# **UT to Cane Creek Restoration Project Year 5 FINAL Monitoring Report**

Subject: Task 11: Response Letter to DMS review comments regarding the Draft Year 5 Monitoring Report for the UT to Cane Creek Restoration Project (#95729)  
Cape Fear Basin – CU#03030002, Alamance County, North Carolina  
Service Contract No. 004951, DMS No. 95729, RFP No. 16-004357, Baker No. 132700

**Current Condition  
Plan View - Figure 4A  
Monitoring Year 5  
UT to Cane Creek Site**

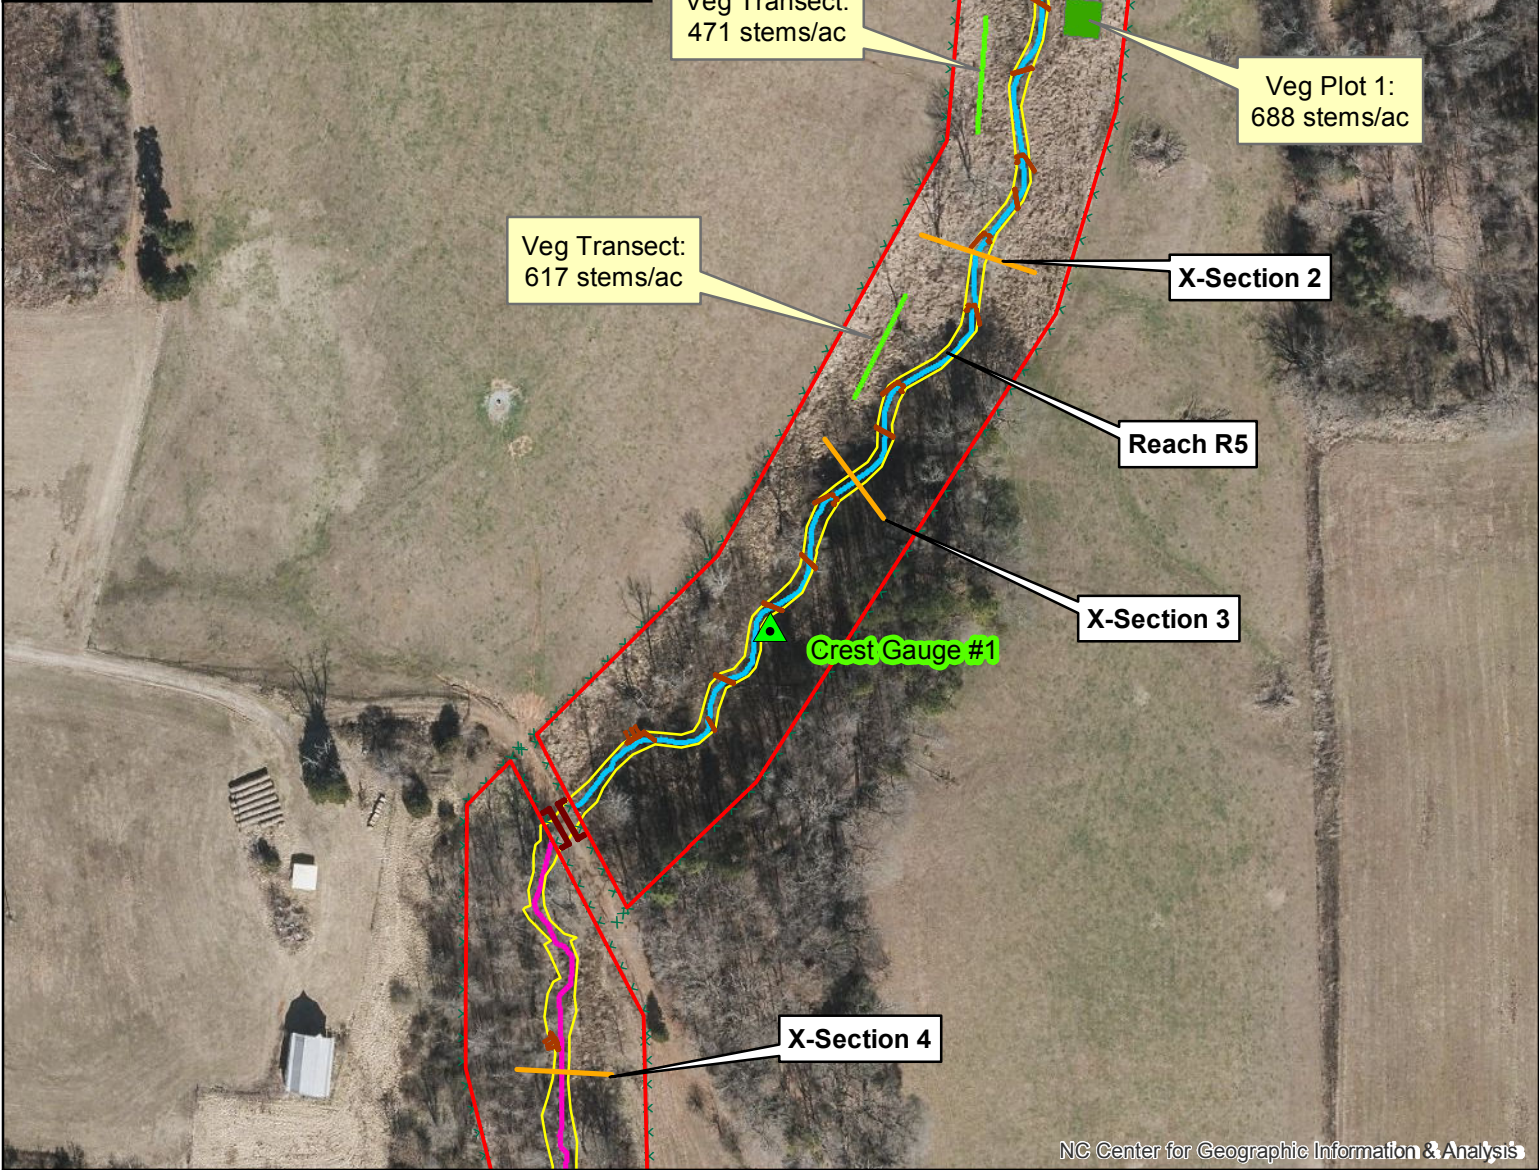
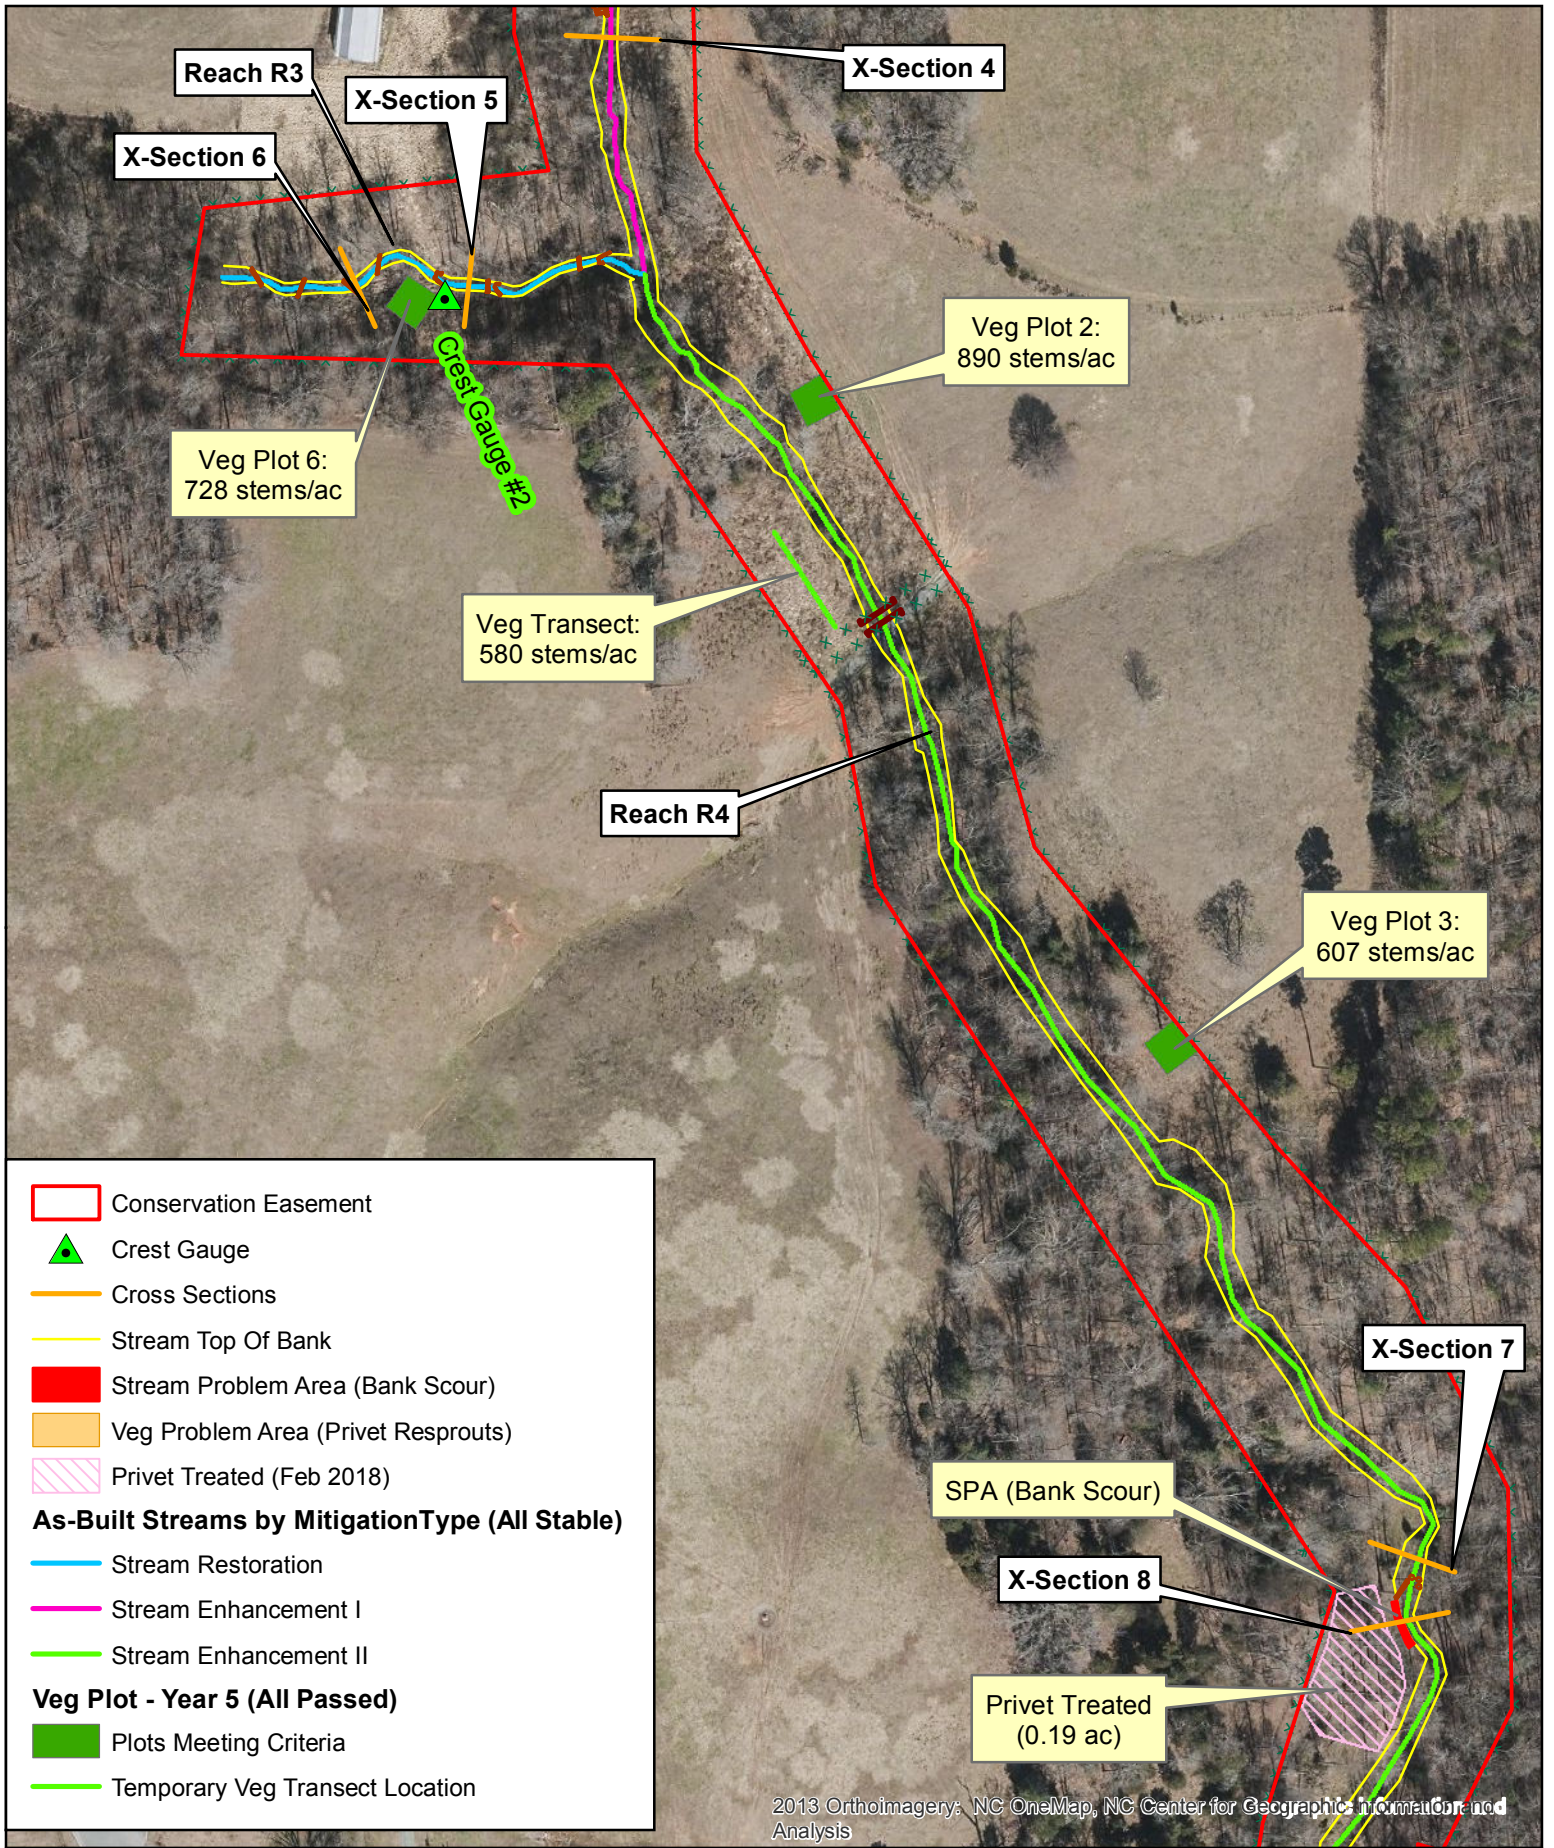
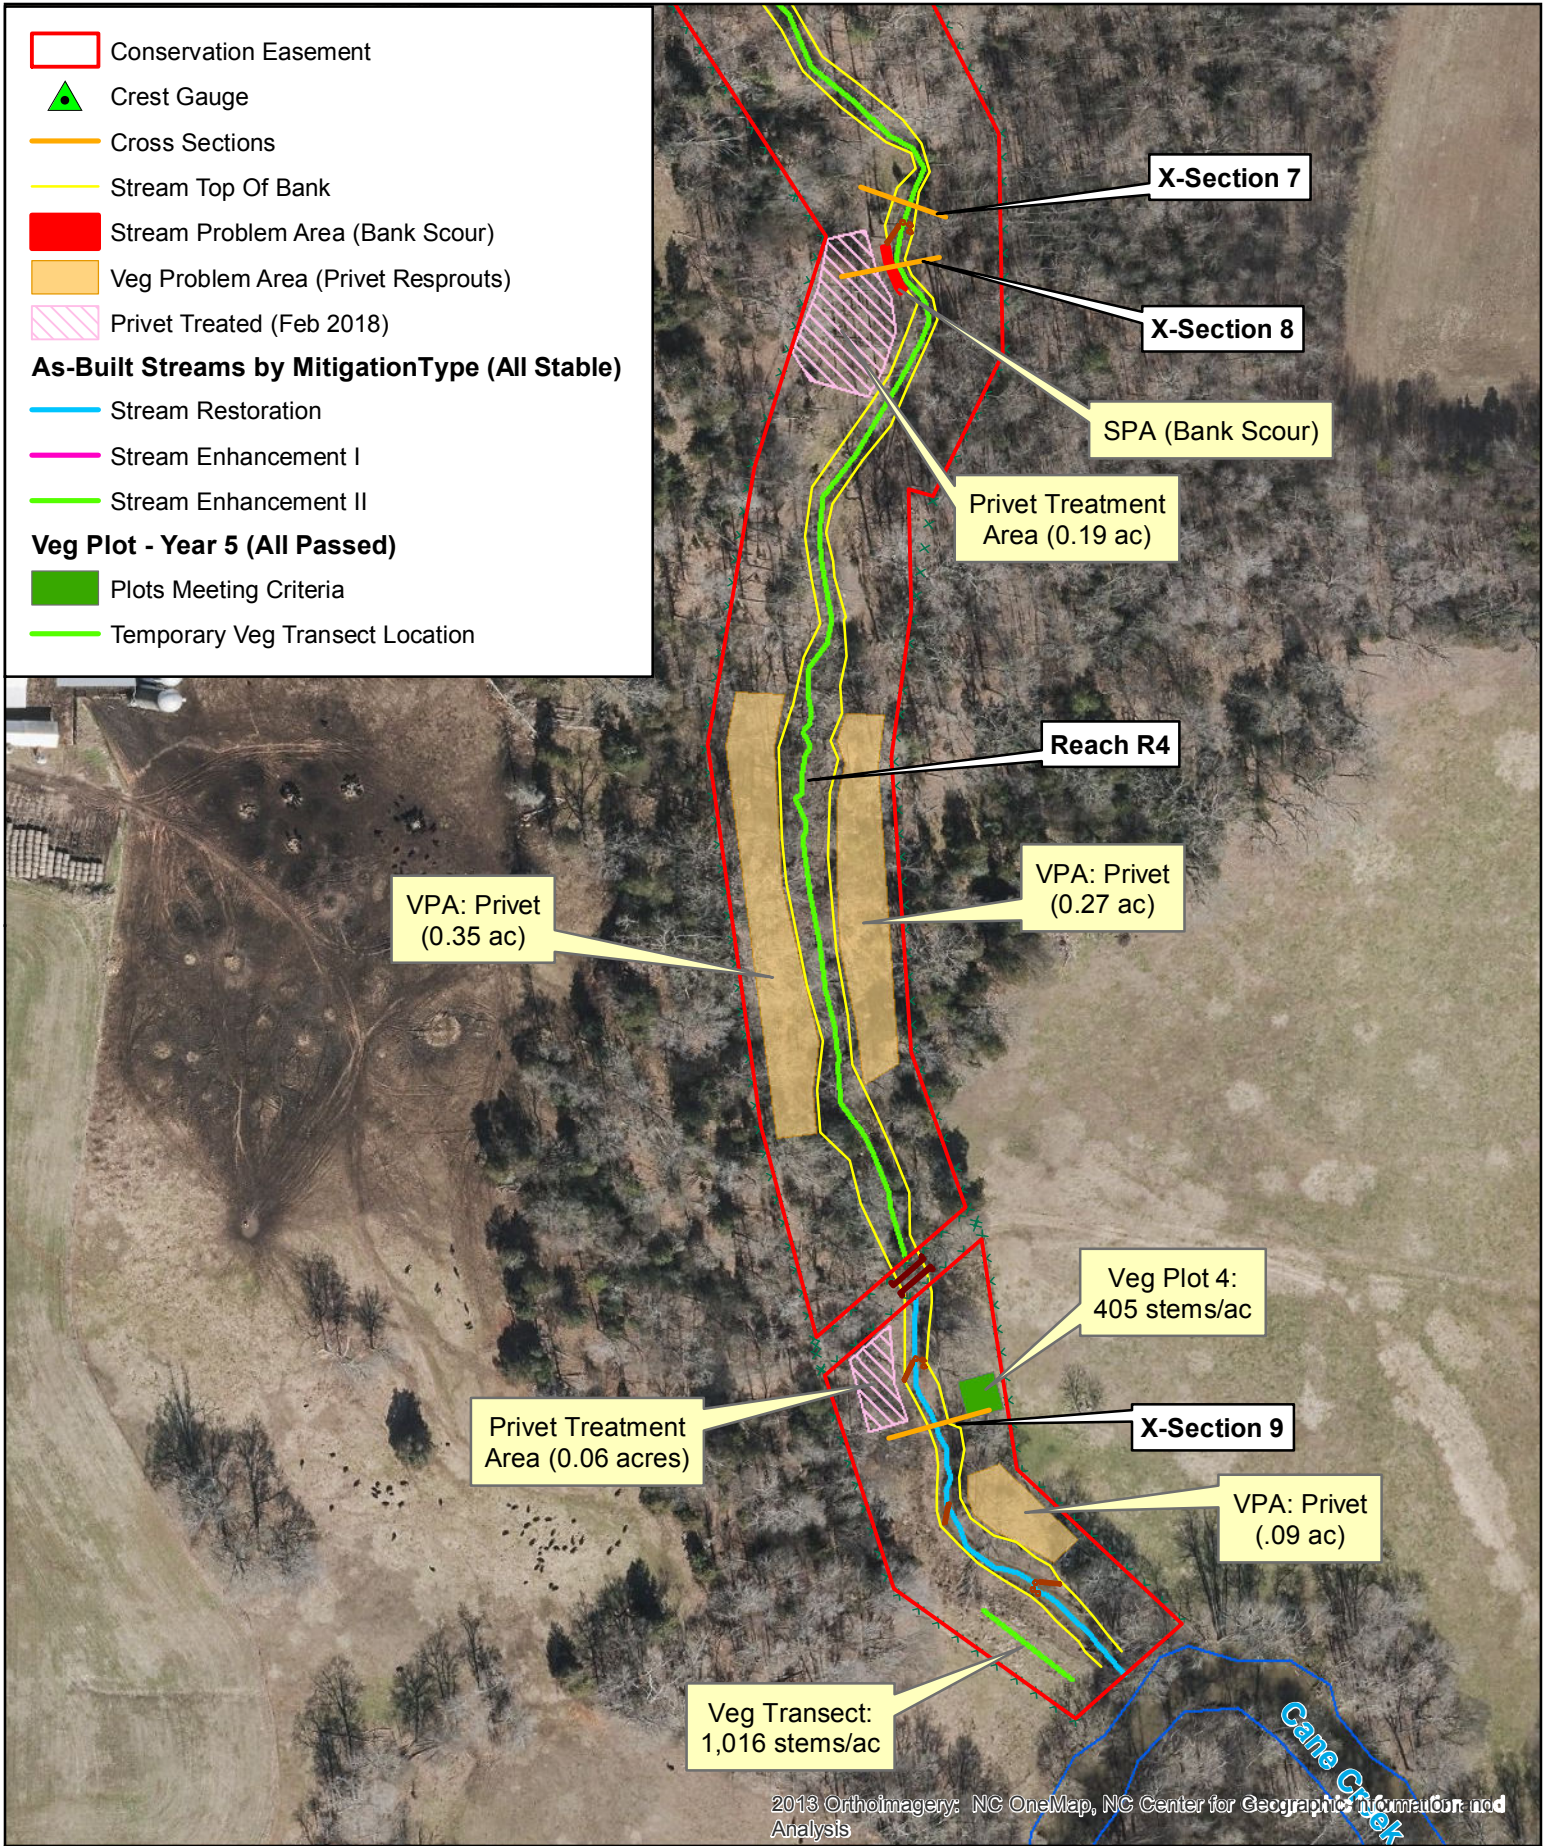
2. Appendix B, CCPV: Recommend using a different color for Privet Treated(Feb 2018). Chosen color is difficult to see.

**Response:** A new color was selected for that layer so that it stands out better.
